Service Bulletin

Bulletin No.: 22-NA-165

Subject: Brake Squeal Noise at Low Speeds

Brand:	Model:	Model Year:		VIN:		Engine:	Transmission:
		from	to	from	to		
Chevrolet	Tahoe PPV	2021	2024

6581016

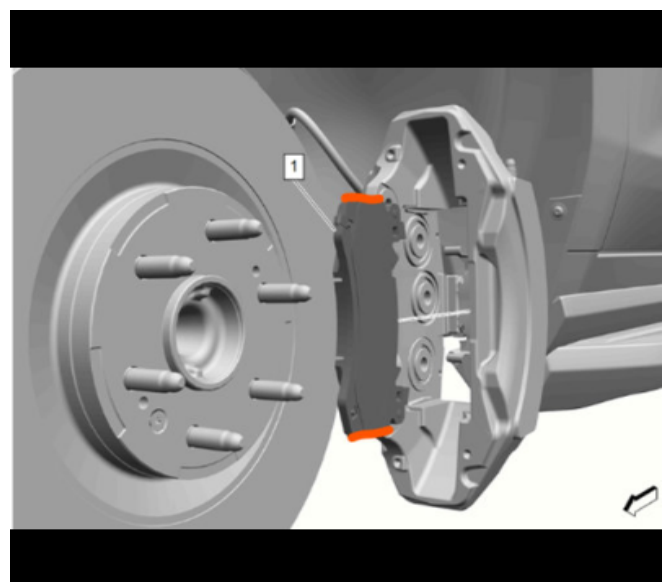
- Apply approximately 0.09-0.15 g (0.003-0.005 oz) of copper past PN# 19303310 (PN# 191303311 Canada) or equivalent on the brake pad abutments (1), as shown in the picture above, which contacts the brake caliper.

Important: DO NOT get any copper paste (grease) on the friction face, **OR** any of the rubber components of the caliper, **OR** on the back of the brake pad.
